**ASHLAND PLANNING DEPARTMENT**      **SITE:**                      74 Westwood St  
**PRE-APPLICATION CONFERENCE**      **APPLICANT:** Jonathan Hall  
**COMMENT SHEET**                              **REQUEST:**      Partition  
September 16, 2020

**PLANNING STAFF COMMENTS:**

Prototypical Section: Residential Neighborhood Street, Parallel Parking One Side

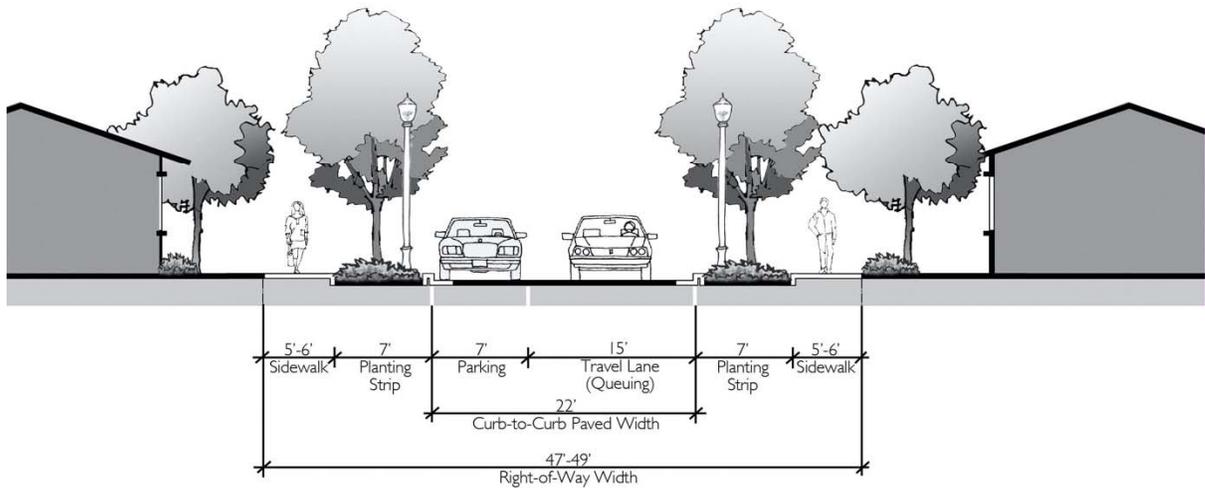
- The application for a partition would need to speak to the adequacy of streets, utilities and drainage to serve an additional lot. Utilities (water, sewer, electric, storm drainage) would typically need to be extended to the newly created lot prior to signature of the final plat. With regard to streets, Westwood Street is a residential neighborhood street and would generally need to be improved to the cross-section illustrated in AMC 18.4.6.040.G.4.b, see below, or an Exception to Street Standards requested. *(If the street is not improved to these standards, the lots would likely need to sign-in favor of a future Local Improvement District (LID) to participate proportionally in any future street improvement project.)*
